SERVICE BULLETIN

Classification:	Reference:	Date:
HA19-002	NTB19-080	October 24, 2019

2014-2020 ROGUE; NO AIR FLOW FROM VENTS DUE TO SNOW BUILD-UP

APPLIED VEHICLES: 2014-2020 Rogue (T32)
2017-2019 Rogue Hybrid (T32H)

Figure 1

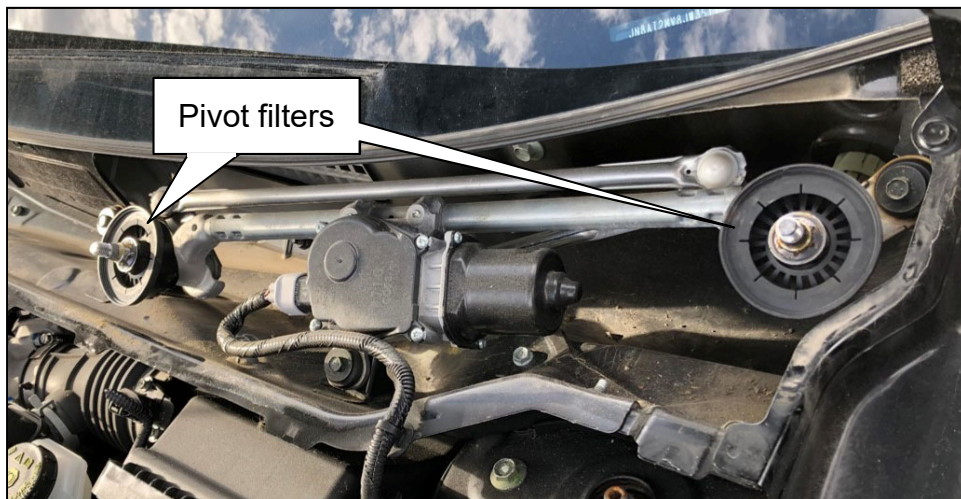
1. Remove all snow, water, and any debris from the HVAC intake, cowl area, and where the blower motor mounts.
 - For removal of the cowl top cover and related parts, refer the Electronic Service Manual (ESM), section **BODY EXTERIOR, DOORS, ROOF & VEHICLE SECURITY – EXTERIOR – REMOVAL AND INSTALLATION – COWL TOP**.
2. Clean or replace the blower motor as needed.
3. If not already equipped: Install a wiper pivot filter on each wiper pivot (see Figure 1).
 - See **PARTS INFORMATION** on the last page of this bulletin.

Make sure to install both wiper pivot filters. If the wiper pivot filters are not installed, snow may enter the blower motor inlet and cause damage to the blower motor.

Figure 2

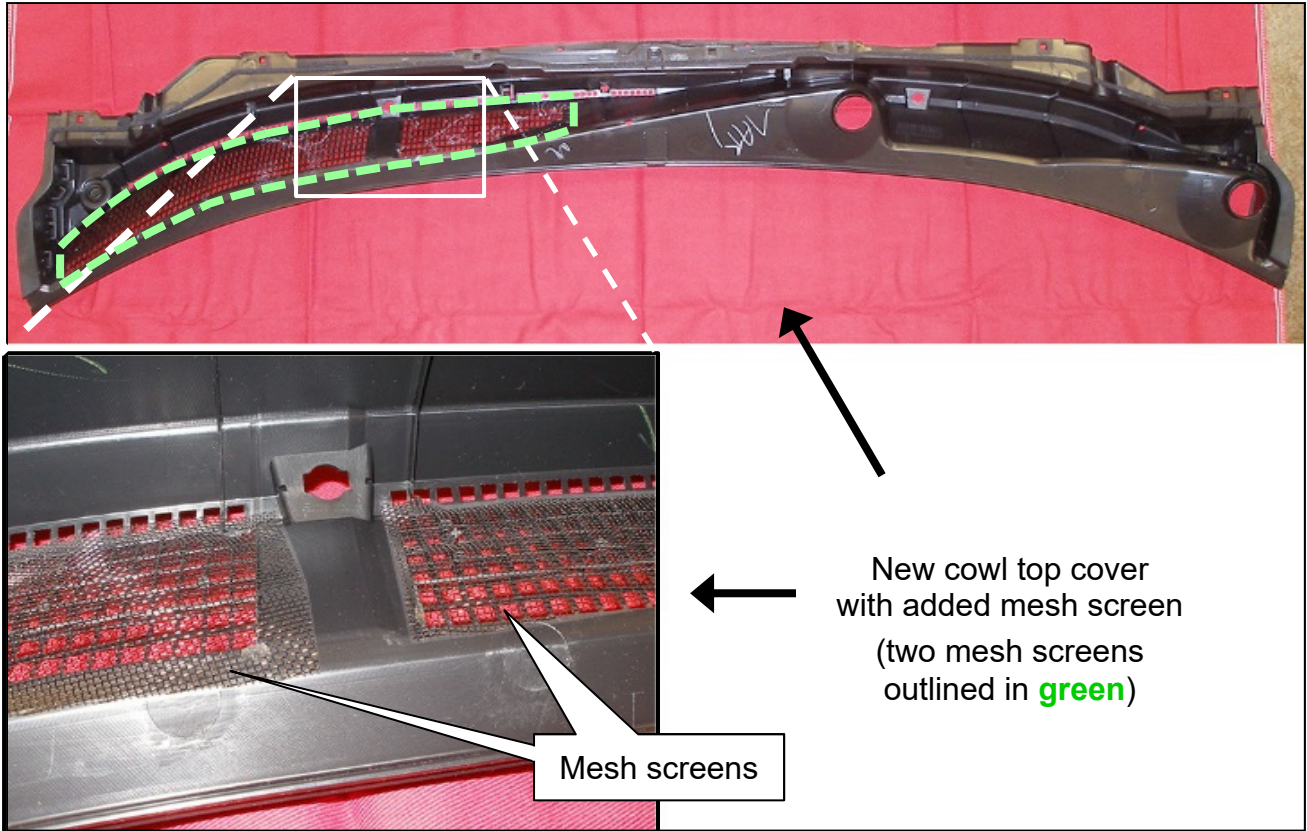
4. Reassemble the vehicle using the new cowl top cover listed in **PARTS INFORMATION**.

Make sure to install the new cowl top cover listed in **PARTS INFORMATION**. If the new cowl top cover is not installed, snow may continue to enter the blower motor inlet and cause damage to the blower motor.
